792-001-11

## ADDENDUM NO. 1

nebraskaGlobal  
Lincoln, NE  
TCEP Project No.: 792-001-11

Supplemental Drawing: #SDA-01  
Revision of Sheet: F1.1  
Date: February 7, 2012

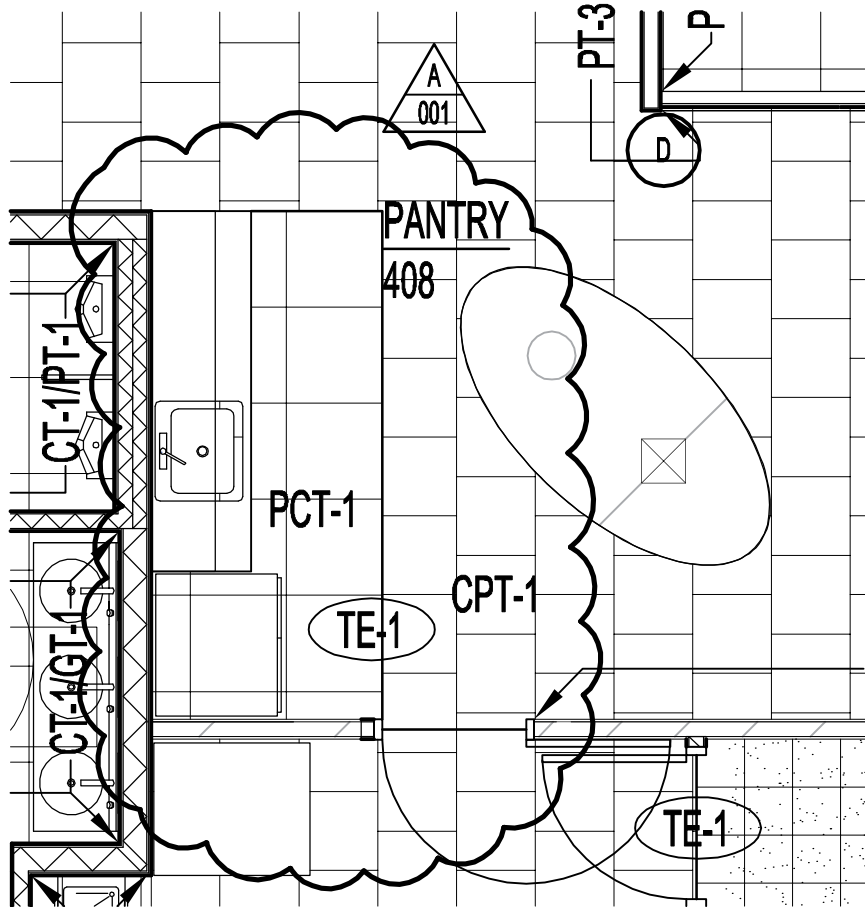
**Item 1-5: Sheet F1.1 – Fourth Floor Finish Plan**

Refer to SDA-01 to revise floor finish in Pantry 408. Pantry 408 shall include both CPT-1 and PCT-1 as drawn.
